## Product Change Notification / SYST-23ZVMN538

ERRATA - AVR64DA28/32/48/64 Silicon Errata and Data Sheet Clarification Document Revision

## AVR64DA Silicon Errata and Data Sheet Clarification

Figure 3-1. Reset System Overview

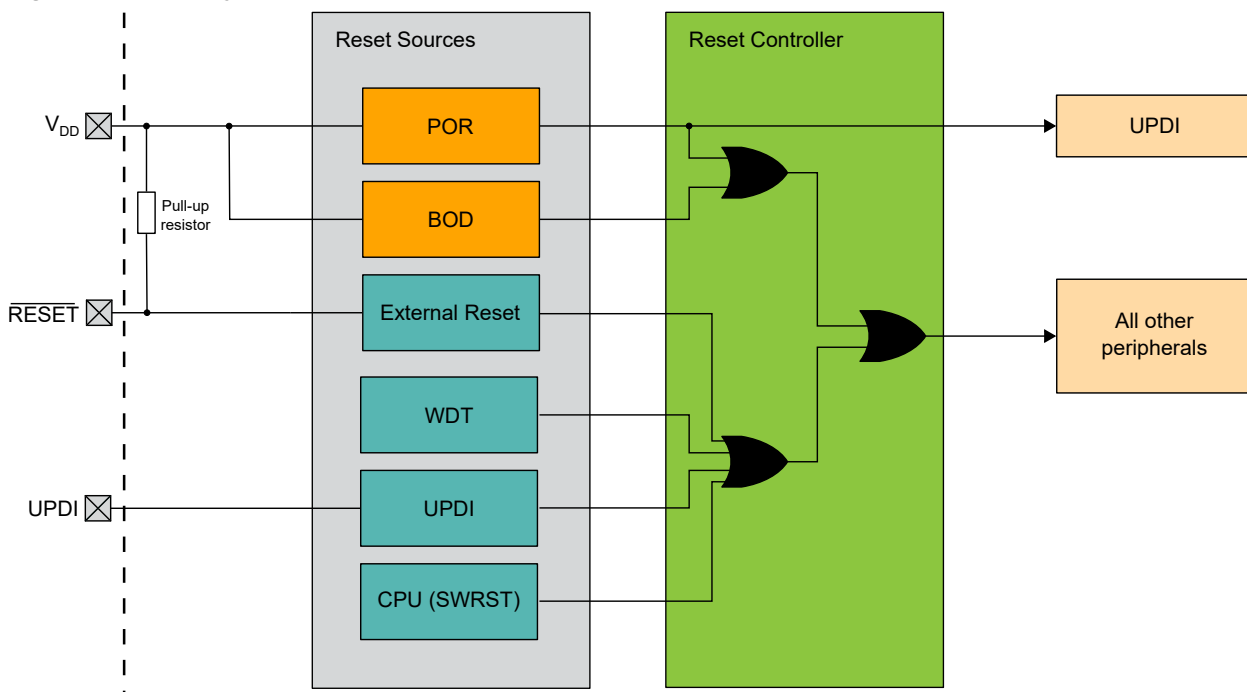
A clarification has been made to add the missing block diagram figure.
